Alabama State Port Authority
Addendum to R&P or Specification Booklet

Project Name Terminal Railway Office Addition/Renovation

Project No. 11012 **Task No.** 02 **Addendum No.** 2

NEW ELECTRICAL AC RISER DIAGRAM

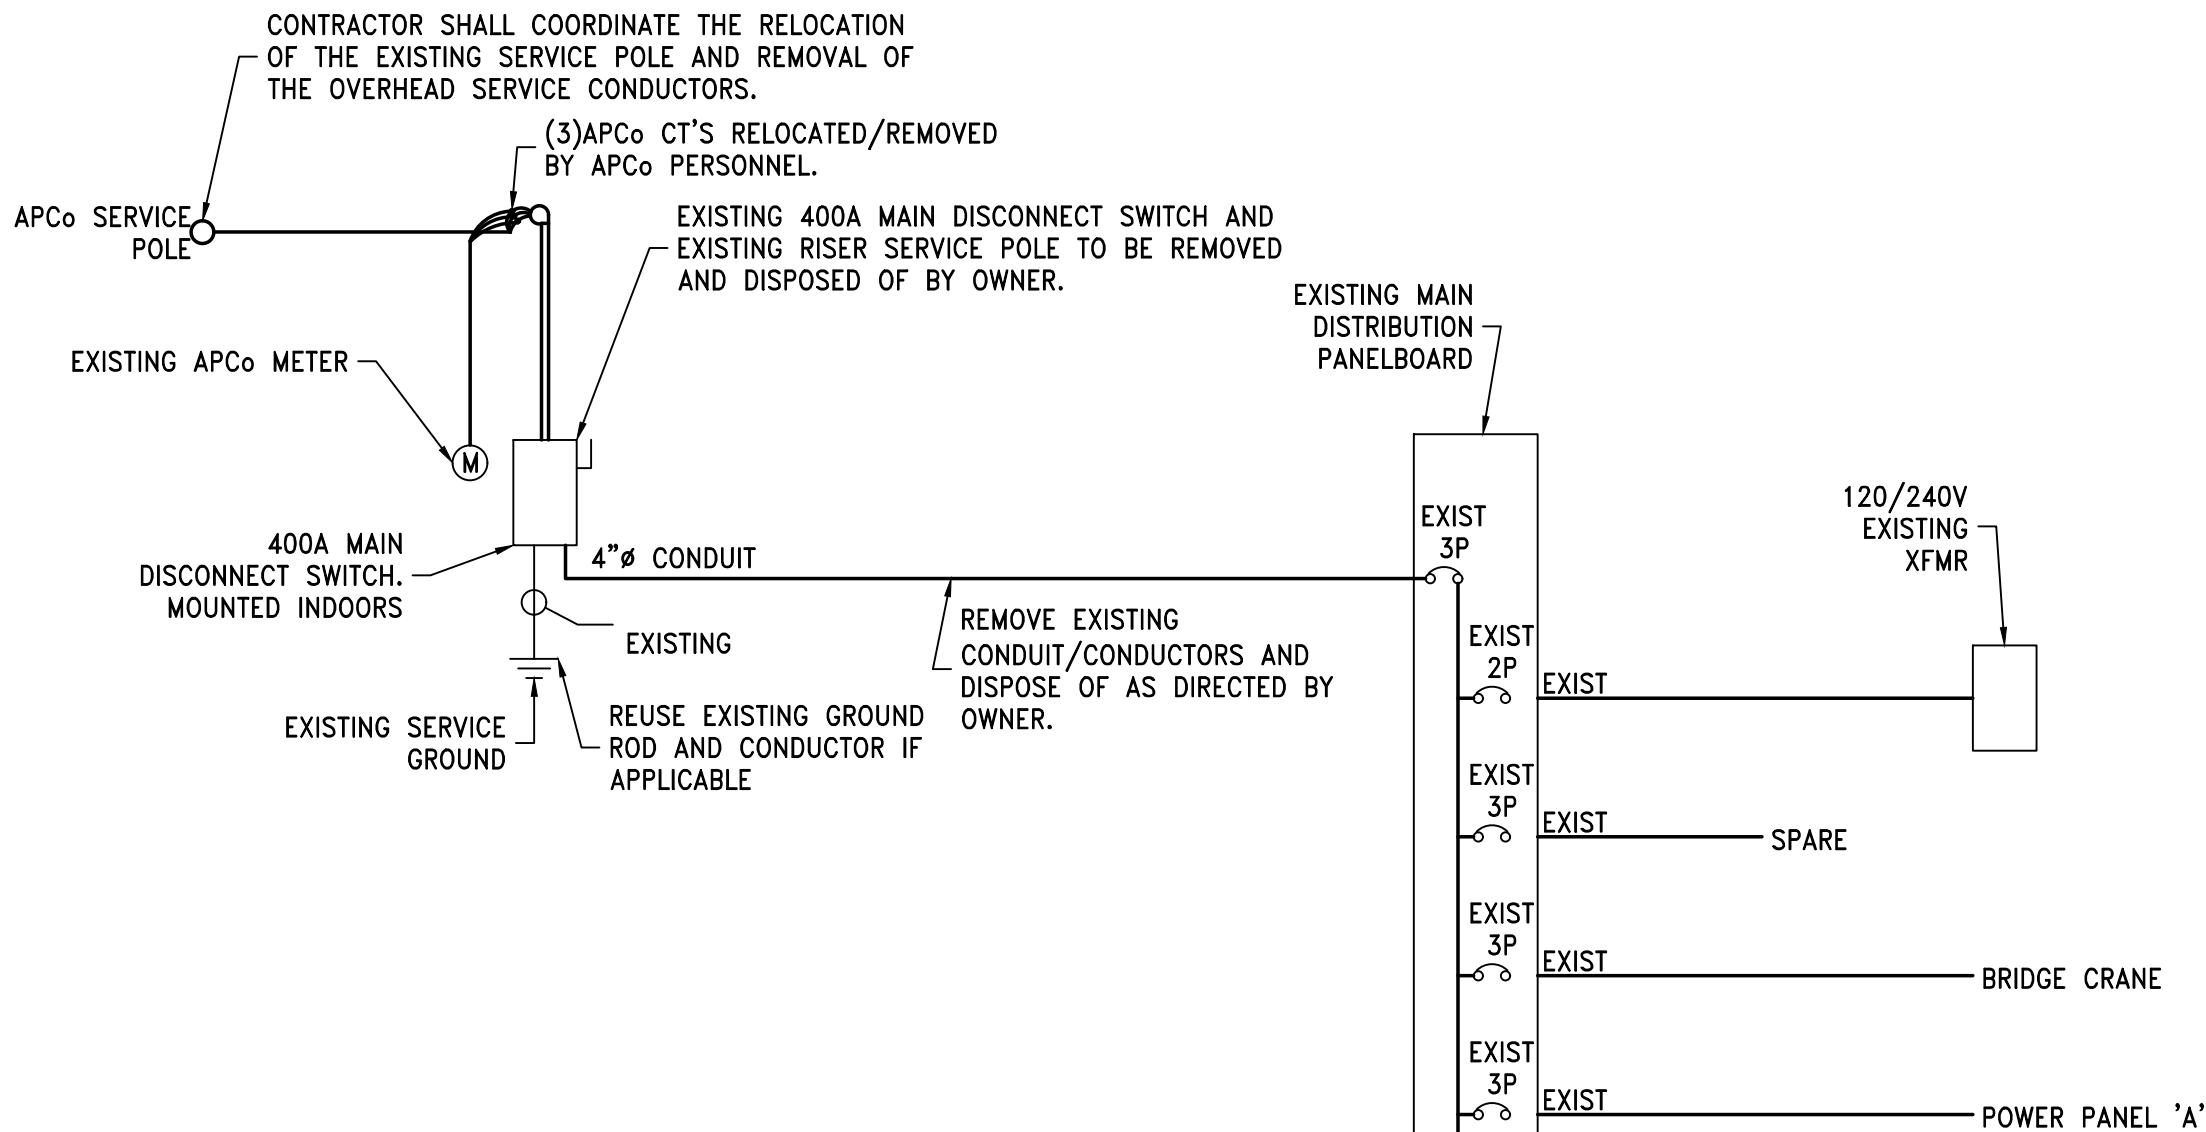
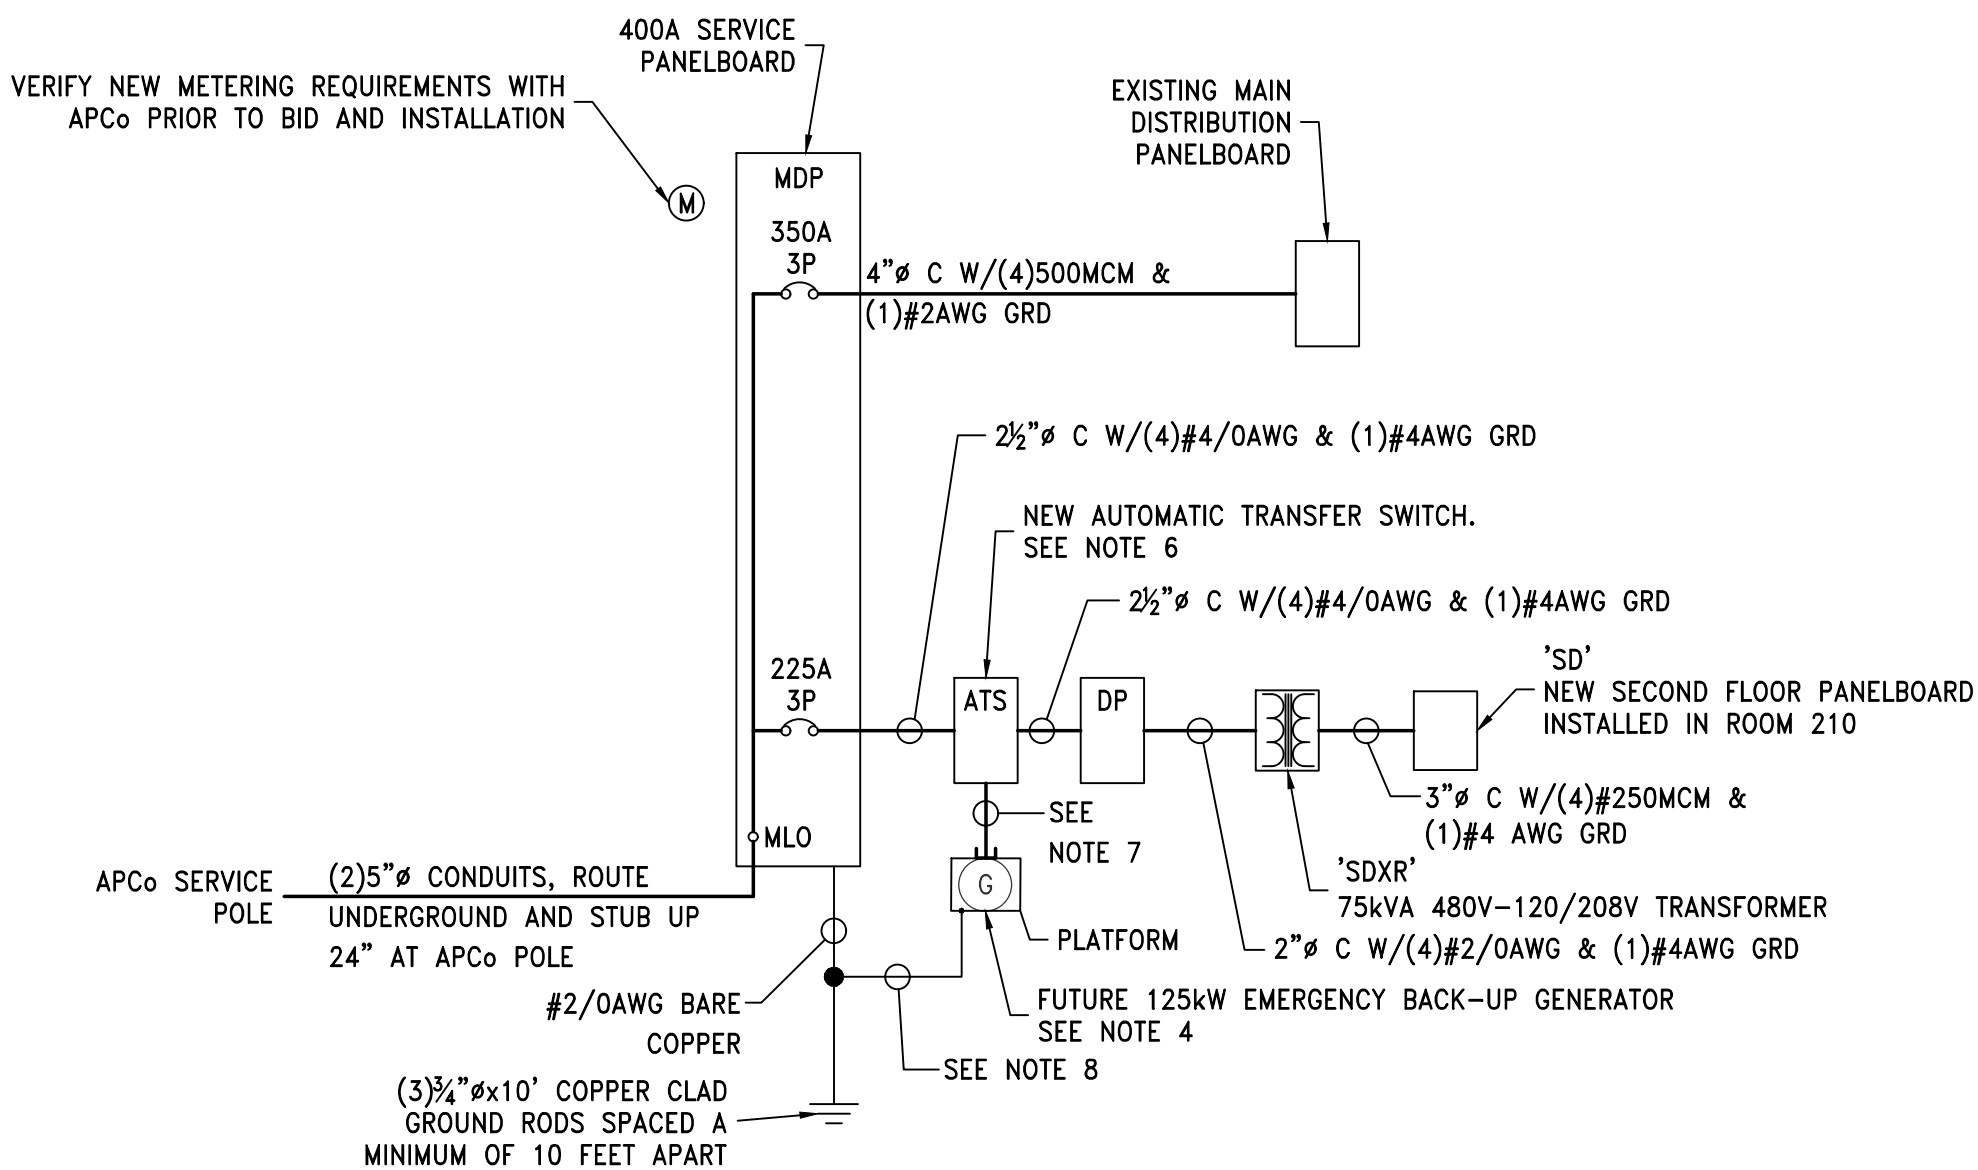
| 21. | <p>Question: In the meeting it was stated by the electrical engineer that the future generator would need the future conduit ran. As per DWG 4146-E5 note 6 this is not the case. Please advise</p> <p>Answer: DWG. 4146-E5 has been revised to state that the future generator and conductors are not part of this contract and that the contractor shall install conduit from the ATS to the generator platform, stub-up, cap and install pull string for future use, see notes 4,7 & 8.</p> <p>DWG. 4146-E5 Rev C is attached and is hereby incorporated into the bid documents by this addendum.</p> |
| 22. | <p>Question: DWG 4146-E5 shows the electrical riser and the panel board coordination schedule. These conflict with each other, please clarify conduit/wire size for new service and service loads.</p> <p>Answer: The electrical riser diagram and panelboard schedules have been revised to reflect the required panelboard coordination schedule requirements.</p> <p>DWG. 4146-E5 Rev C is attached and is hereby incorporated into the bid documents by this addendum.</p> |
